WOLF CREEK

November 18, 2005
ET 05-0025

Subject: Docket No. 50-482: Supplement to Revision to Technical Specifications – Extensions of AC Electrical Power Distribution Completion Times

ATTACHMENT II
MARKUP OF TECHNICAL SPECIFICATION PAGES

INSERT 2

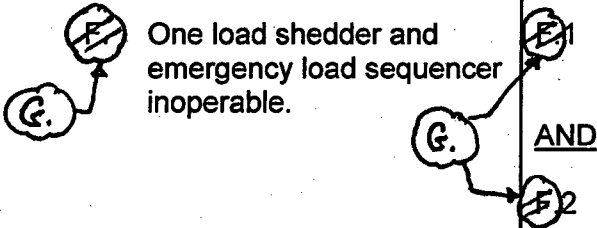
-----NOTE-----
Required Actions B.4.2.1 and B.4.2.2 are only applicable for planned maintenance and may be used once per cycle per DG.

<p style="text-align: center;"><u>OR</u></p> <p>B.4.2.1 Verify the required Sharpe Station gensets are available.</p> <p style="text-align: center;"><u>AND</u></p> <p>B.4.2.2 Restore DG to OPERABLE status.</p>	<p>Once per 24 hours</p> <p>7 days</p> <p style="text-align: center;"><u>AND</u></p> <p>10 days from discovery of failure to meet LCO</p>
--	---	--

C. Required Action B.4.2.1 and associated Completion Time not met.	C.1 Restore DG to OPERABLE status.	72 hours
--	------------------------------------	----------
